SUBJECT: SEABROOK STATION, UNIT 1 - STAFF ASSESSMENT OF INFORMATION PROVIDED PURSUANT TO TITLE 10 OF THE *CODE OF FEDERAL REGULATIONS* PART 50, SECTION 50.54(f), SEISMIC HAZARD REEVALUATIONS FOR RECOMMENDATION 2.1 OF THE NEAR-TERM TASK FORCE REVIEW OF INSIGHTS FROM THE FUKUSHIMA DAI-ICHI ACCIDENT (TAC NO. MF3921)

STAFF ASSESSMENT BY THE OFFICE OF NUCLEAR REACTOR REGULATION

RELATED TO SEISMIC HAZARD AND SCREENING REPORT

SEABROOK STATION, UNIT 1

Figure 3.2-1 Plot Comparing the Staff's and the Licensee's Mean Control Point Hazard Curves at a Variety of Frequencies at the Seabrook site

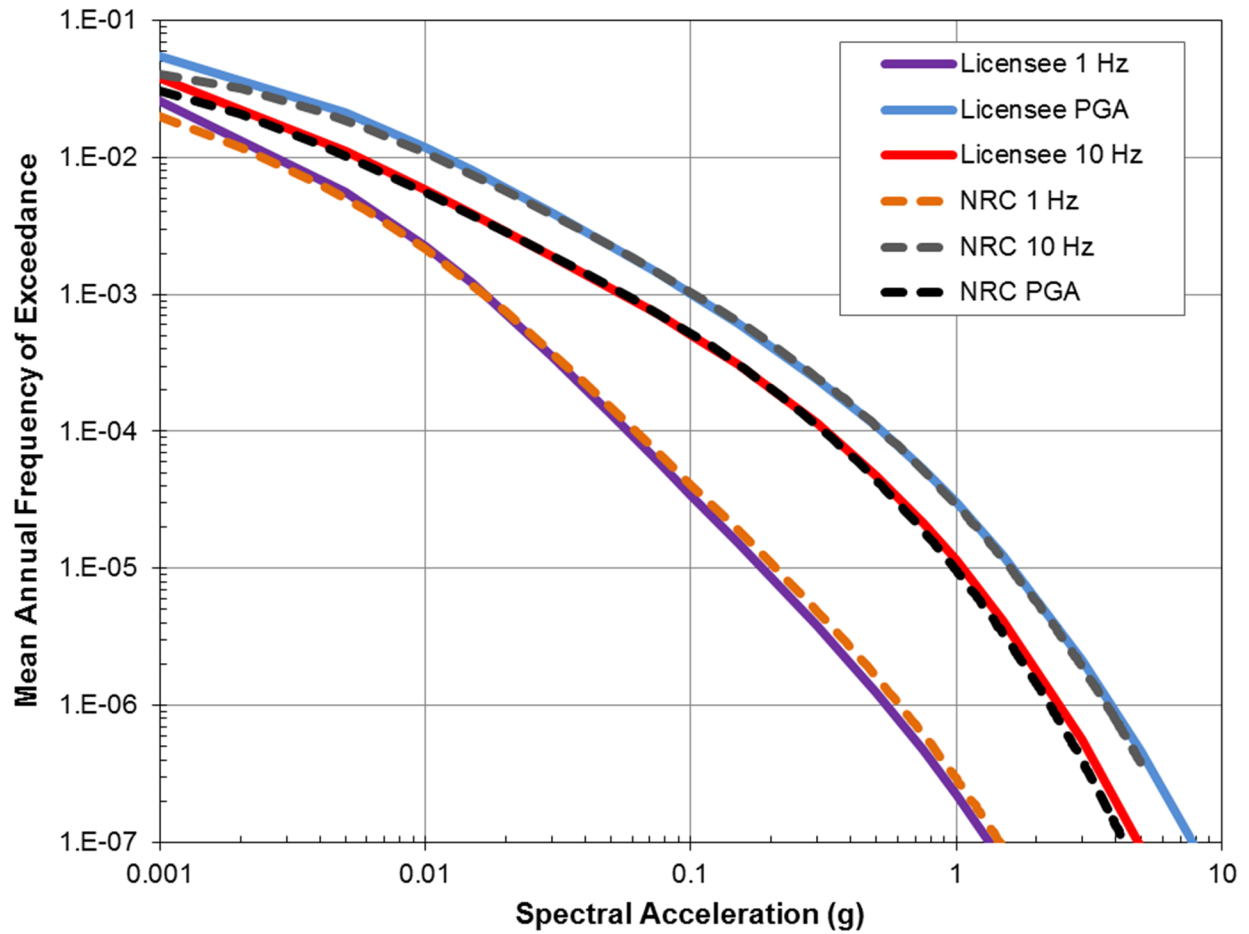
Based on its review of the SHSR, the NRC staff concludes that the licensee appropriately followed the guidance provided in the SPID for selecting the PSHA input models and parameters for the site. This includes the licensee's use and implementation of the CEUS-SSC model and the updated EPRI GMM model. The NRC staff's and licensee's control point rock seismic hazard curves are compared in Figure 3.2-1 of this assessment and show no appreciable differences.

Figure 3.4-1 Comparison of the Staff's GMRS with Licensee's GMRS and the SSE for the Seabrook site

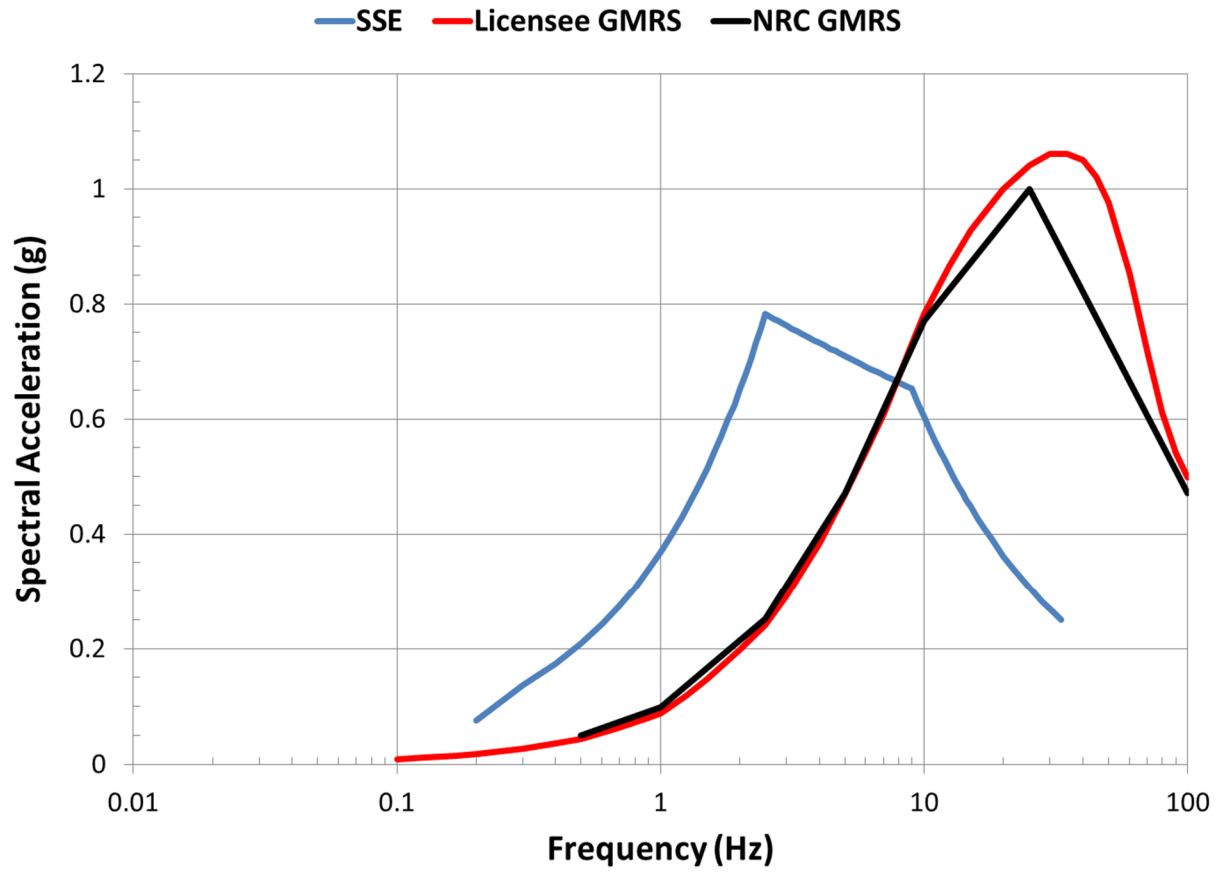
The NRC staff independently calculated the 10^{-4} and 10^{-5} UHRs using the results of its confirmatory PSHA, as described in Sections 3.2 and 3.3 of this staff assessment. Figure 3.4-1 of this assessment shows a comparison of the GMRS determined by the licensee to that determined by the staff. As shown in Figure 3.4-1, the licensee's and NRC staff's GMRS is similar to that calculated by the NRC staff. The difference in spectral accelerations at 25 Hz is only 4 percent. The difference between the staff's and licensee's GMRS above 10 Hz is primarily due to differences in interpolation between calculated spectral accelerations. The NRC staff concludes that these differences are acceptable for this application because the licensee followed the guidance provided in the SPID for the Seabrook site. The SPID provides guidance that is neither fully prescriptive nor comprehensive. As such, various approaches in performing analyses are acceptable for this application.

The NRC staff confirms that the licensee used the present-day guidance and methodology outlined in RG 1.208 and the SPID to calculate the horizontal GMRS, as requested in the 50.54(f) letter. The staff performed a PSHA confirmatory analysis and achieved results consistent with the licensee's horizontal GMRS. As such, the NRC staff concludes that the GMRS determined by the licensee adequately characterizes the reevaluated hazard for the Seabrook site. Therefore, this GMRS is suitable for use in subsequent evaluations and confirmations, as needed, for the response to the 50.54(f) letter.
